## ASSESSMENT REPORT

### Building R1, Barangaroo South SSD 6513 MOD 3

This report provides an assessment of a section 96(1A) modification application lodged by Lend Lease (Millers Point) Pty Ltd (the Applicant) seeking to modify a State significant development application (SSD 6513) for the construction and use of Building R1 as a pub at Barangaroo South within the City of Sydney local government area. The application seeks approval for design amendments to the ground floor planter boxes, four signage zones and minor ground floor design and layout amendments.

Figure 4: Proposed modifications to ground floor fit-out (Source: Applicant)

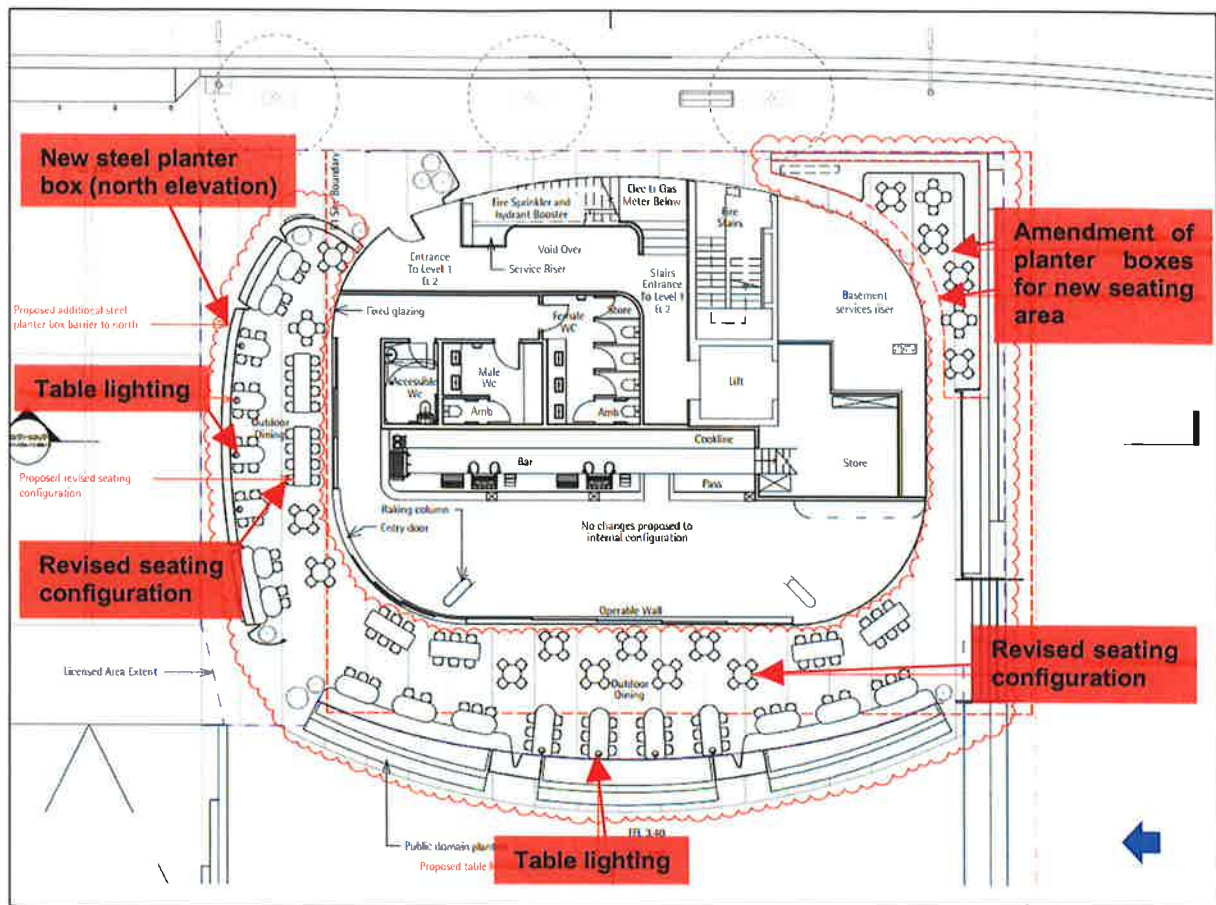
Council raised concern the proposed new ground floor seating zone in the south-eastern corner of the building (**Figure 4**) is isolated and visually separated from other areas of the building which would limit the ability of staff to properly managed patrons within that space. Concern was also raised CPTED principles had not been thoroughly considered as part of the application.

In response to Council's concerns, the Applicant acknowledges that while the new seating area is separate from the primary outdoor seating area, it is located in a highly visible location within the public domain at Barangaroo South as it is located at a key gateway to the precinct with limited screening (i.e. the corner of Shelley and Lime Streets). Further, the Applicant considered the low height design of the folded metal planter box in the south-east corner provides appropriate separation and demarcation of the public and private domain without limiting opportunities for casual surveillance.

The Department acknowledges Council's concerns but is satisfied CPTED principles have been suitably considered in the design of the additional seating area. Further, the Department is satisfied patrons in the new seating area would safely and be efficiently managed by staff in accordance with the approved POM for the premises. The new seating area would also activate the south-eastern corner of the building and the adjacent public domain and is therefore supported.

Figure 5: Proposed modifications to northern elevation (Source: Applicant)

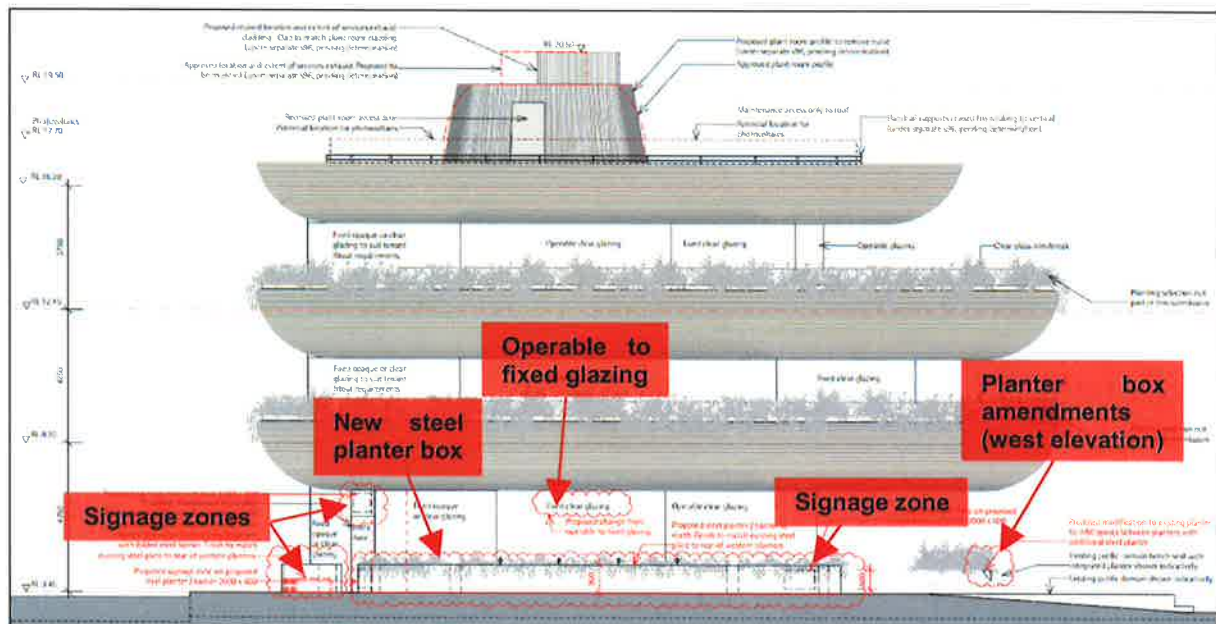
A total of four signage zones (**Figure 5**) would be integrated into the ground floor building design and layout as follows:

Council requested more detailed plans be provided showing how the proposed signage zones integrate with structures.

The Department is satisfied the proposed signage zones are acceptable as they are appropriately sized and located, would be integrated into the design structures in the outdoor dining area so they would not adversely impact on the design of the building or the adjacent public domain, and would comply with the assessment criteria in SEPP 64.

**Figure 6:** Diagram showing design of proposed folded metal planter boxes (Source: Applicant)

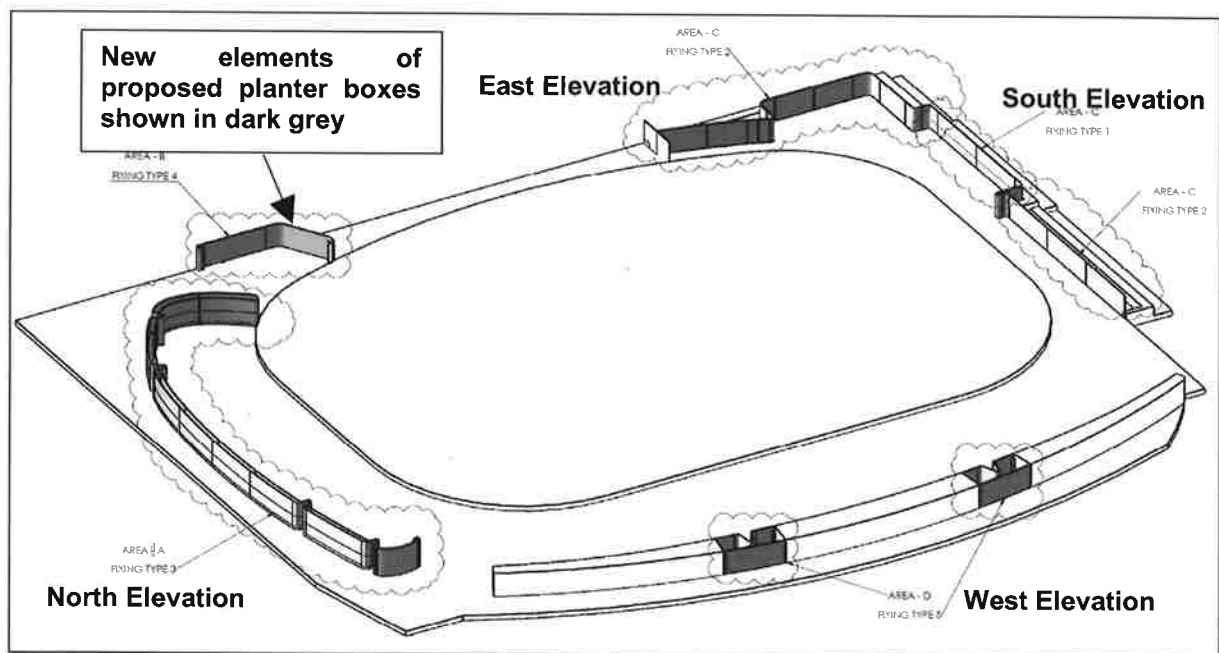
Council requested more detailed plans be provided showing the folded metal planter boxes.

In response to Council's concerns, the Applicant provided additional diagrams 'for information' which illustrate the proposed folded metal planter boxes in more detail (**Figure 6**).

The Department has reviewed the information provided and notes the proposed planter boxes have been architecturally treated, integrated into the design of the existing landscaping and appropriately sized to ensure they do not interfere with or detract from the adjoining public domain. The landscaping and materiality (steel) of new planter boxes would be consistent with the approved design.

Given the above, the Department supports the design of the modified planter boxes and is satisfied they would not adversely impact on the surrounding public domain.
